# LINCOLN PROFESSIONAL PARK FILING NO. 1 LOT 1 MAVERIK INC. STORE SITE PLAN

No.	Date	Description
1	5-24-22	CITY REVIEW
2	7-13-22	CITY REVIEW

**MAVERIK INC. STORE**  
**LINCOLN AVE. AND DRANSFELDT RD.**  
**PARKER, CO**  
**SITE PLAN**

HORIZONTAL CONTROL PLAN

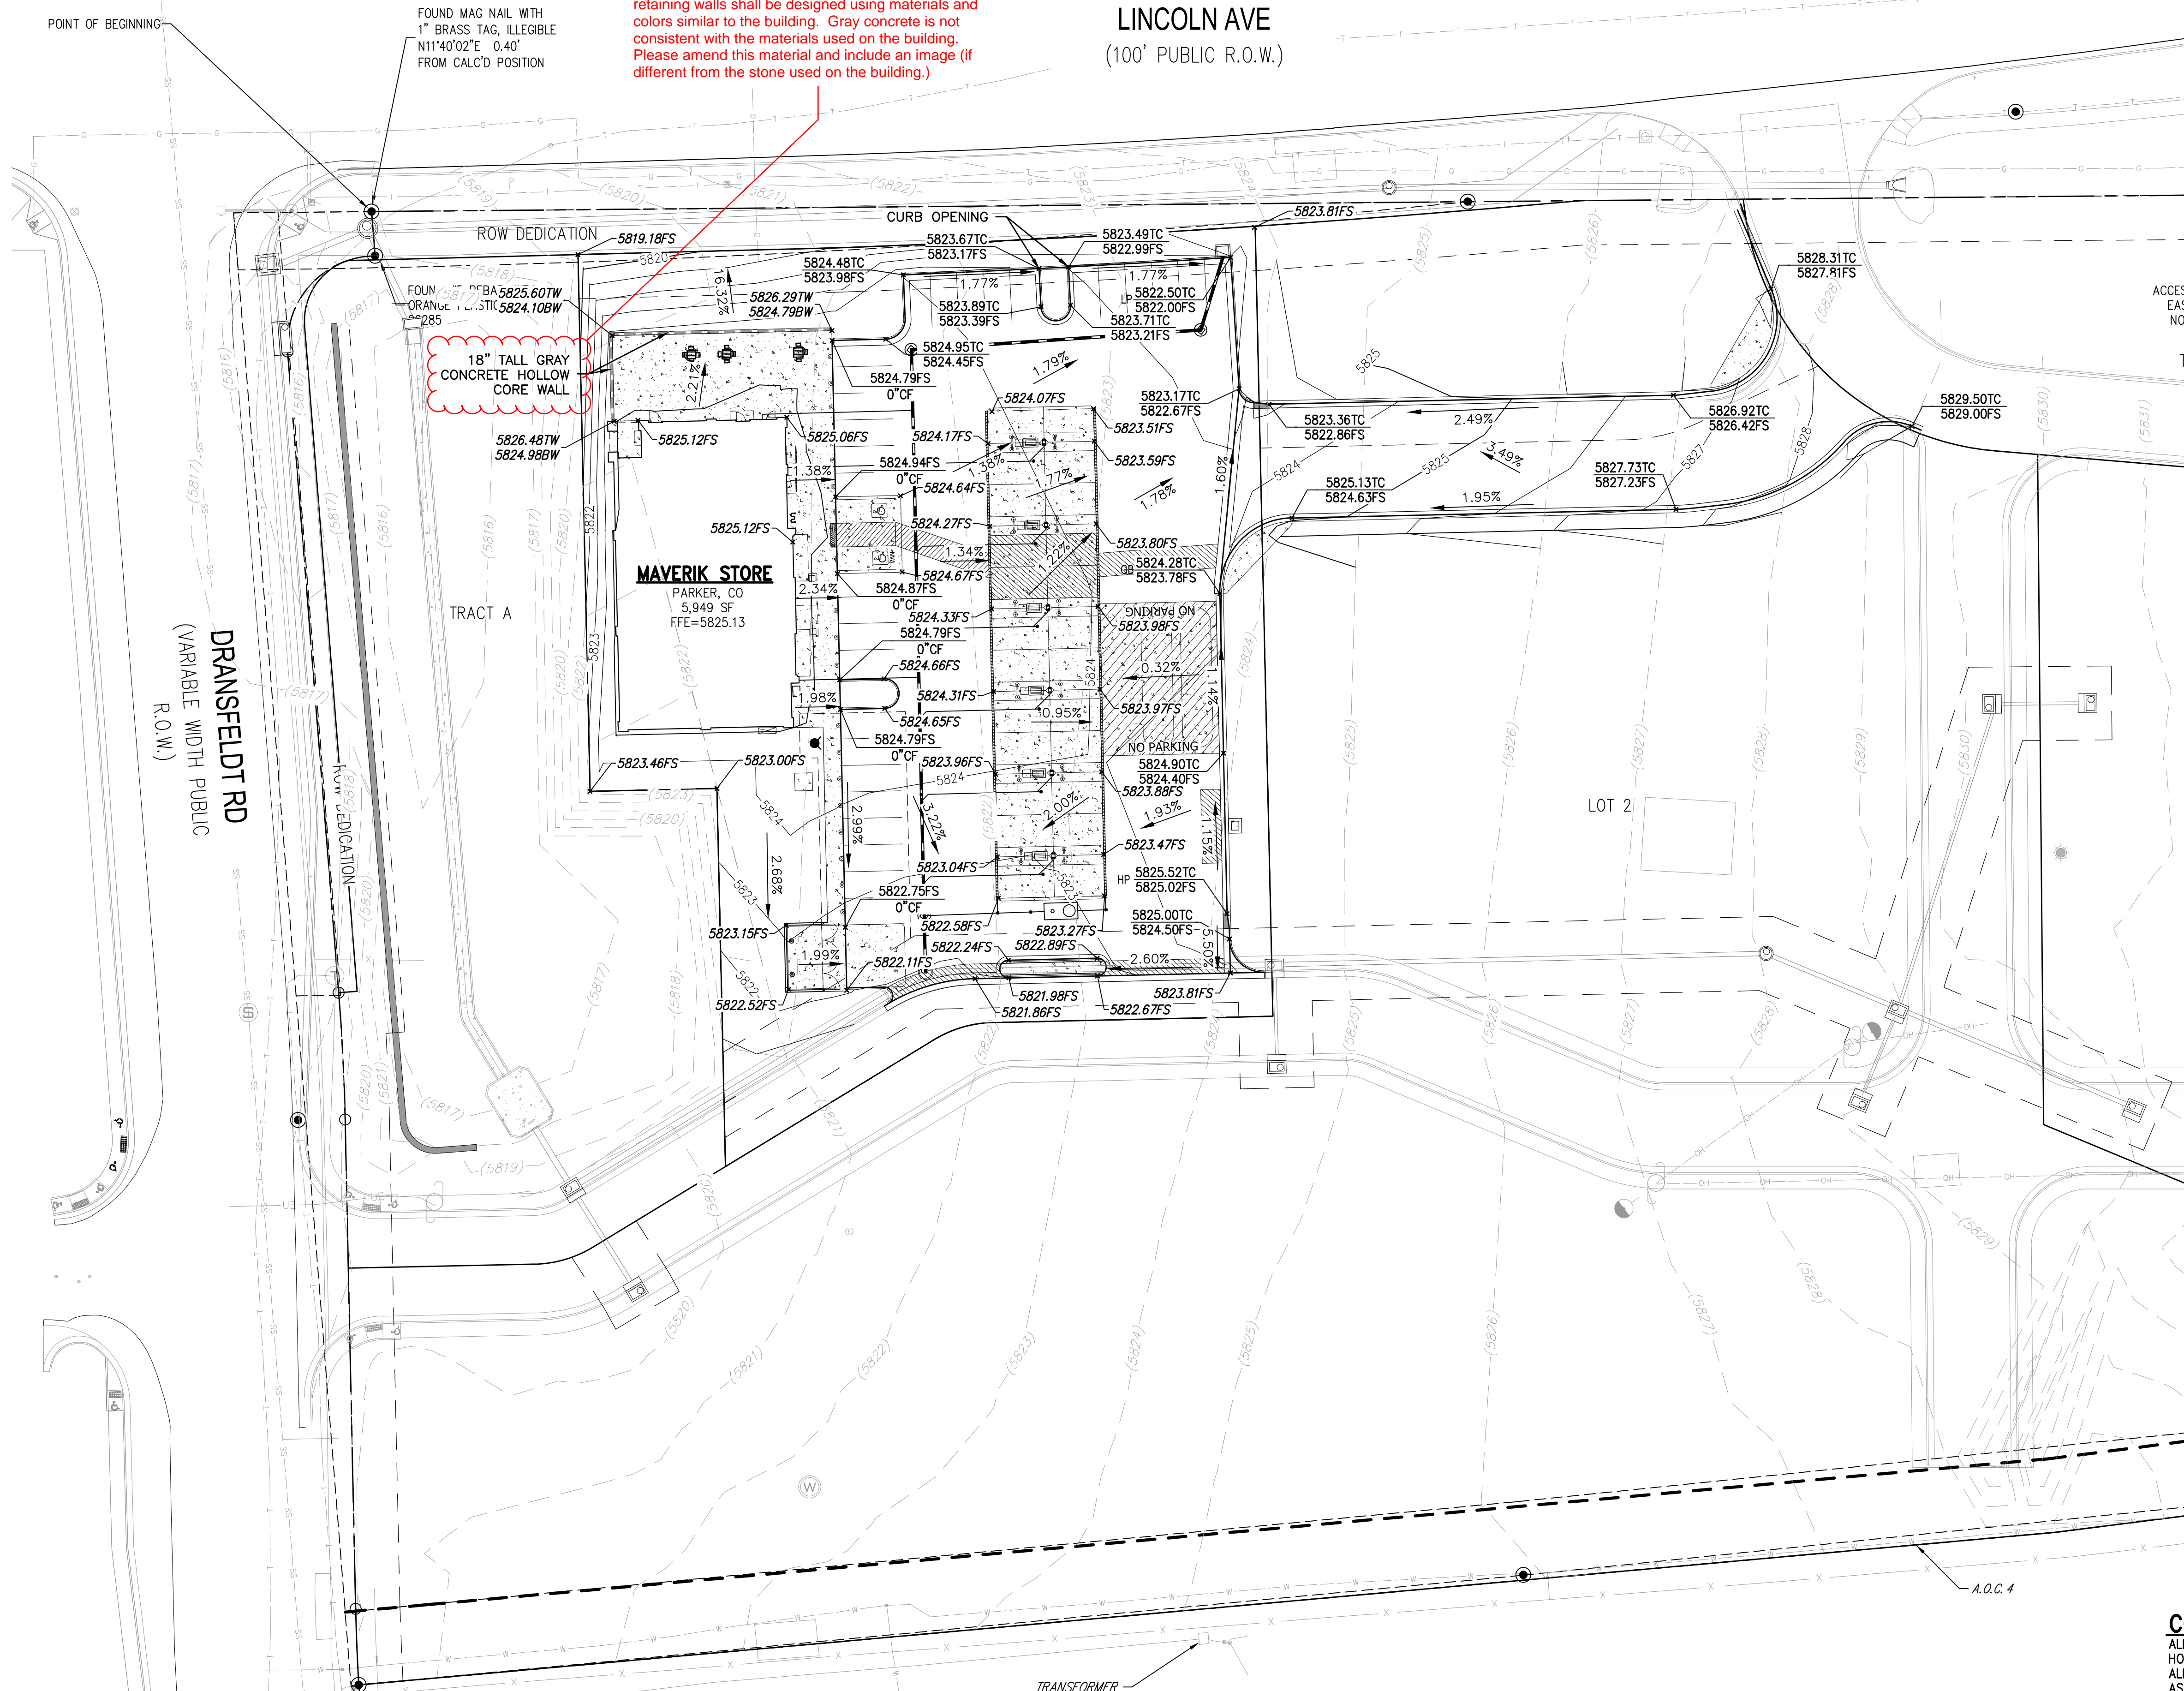
**DUE TO THE 16% SLOPE FROM THE PARKING AREA TO THE BACK OF WALK ALONG LINCOLN AVE, A PEDESTRIAN CONNECTION WOULD NOT BE POSSIBLE.**

Staff understands that there is a slope to the sidewalk, but is there a way to create a pedestrian connection from the Lincoln Road sidewalk to access the building? Based on the Town of Parker Land Development Ordinance, pedestrian connections from the adjacent sidewalk to each commercial use is recommended.

Need a pedestrian connection into the site from the internal road. If walking in front of the trash enclosure is not preferred, a path can be added to west.  
**THIS PEDESTRIAN CONNECTION HAS BEEN ADDED**

GRADING PLAN

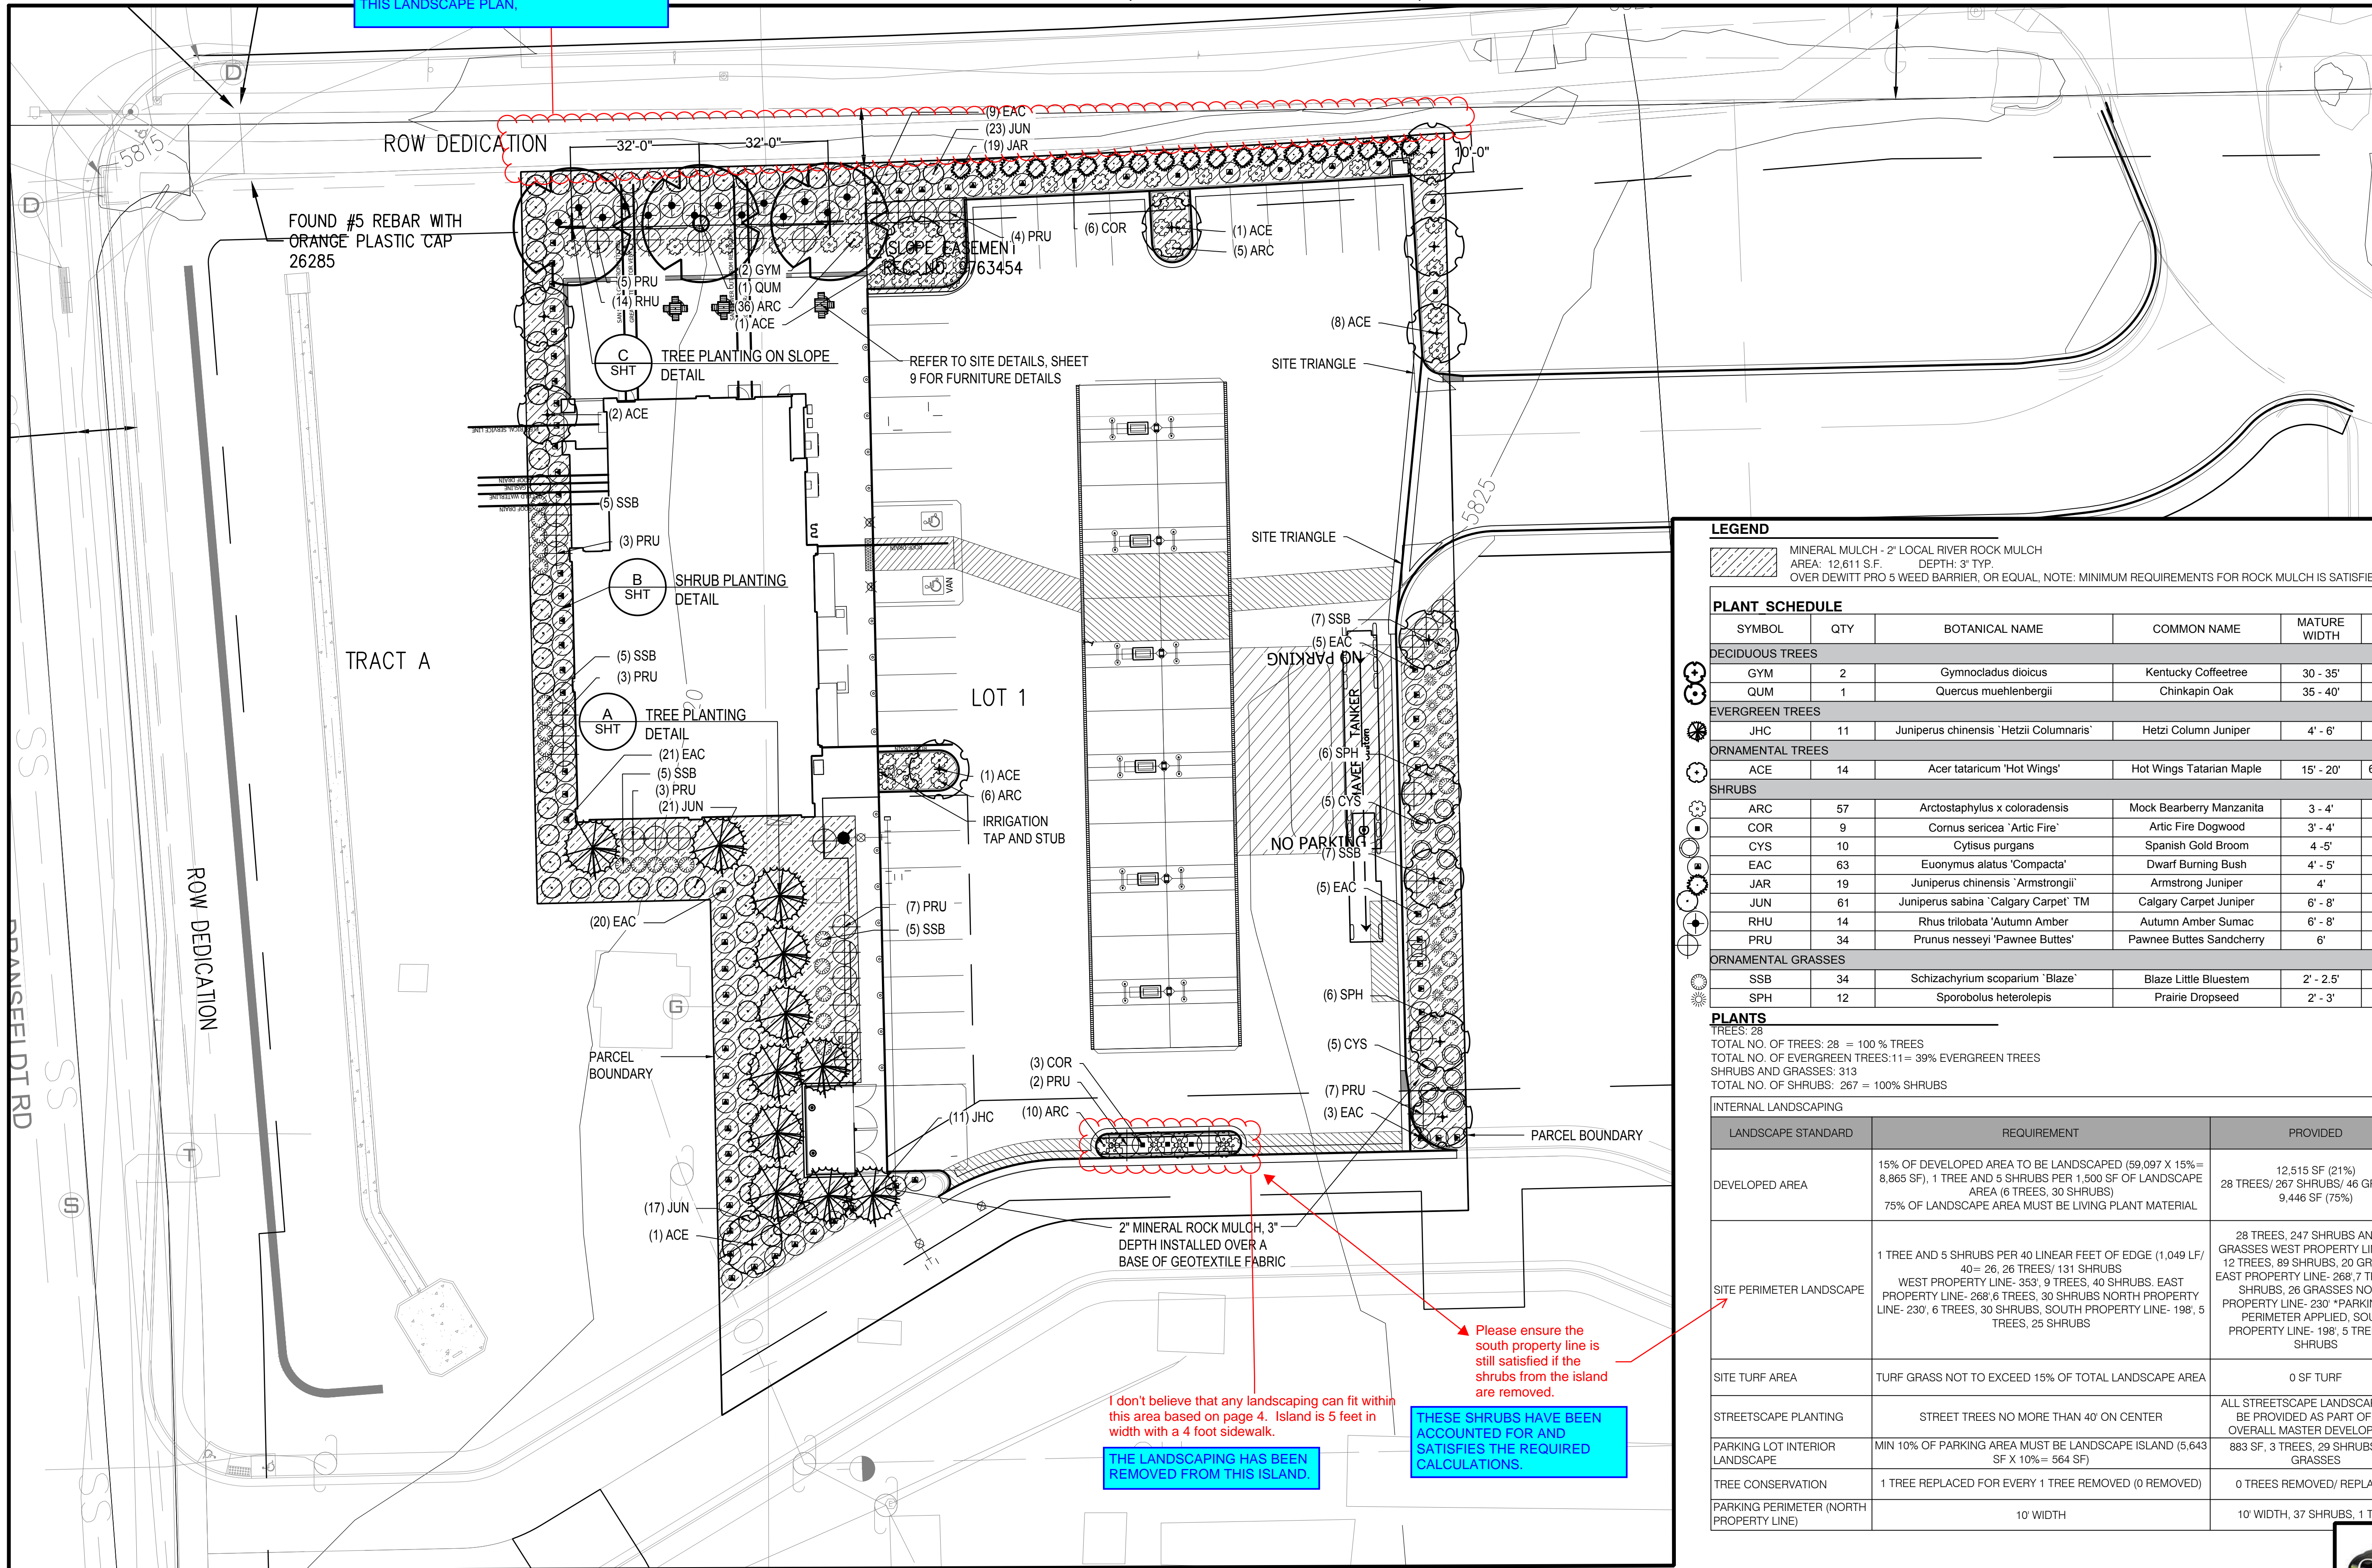
Thank you for including additional details, but please also include an image of the concrete on this page. All retaining walls shall be designed using materials and colors similar to the building. Gray concrete is not consistent with the materials used on the building. Please amend this material and include an image (if different from the stone used on the building.)

A DETAIL OF THIS WALL HAS BEEN PROVIDED BY THE ARCHITECT AND HAS BEEN INSERTED IN THIS SHEET. IT SHOWS THE MATERIALS BEING USED WILL MATCH THE EXTERIOR OF THE BUILDING
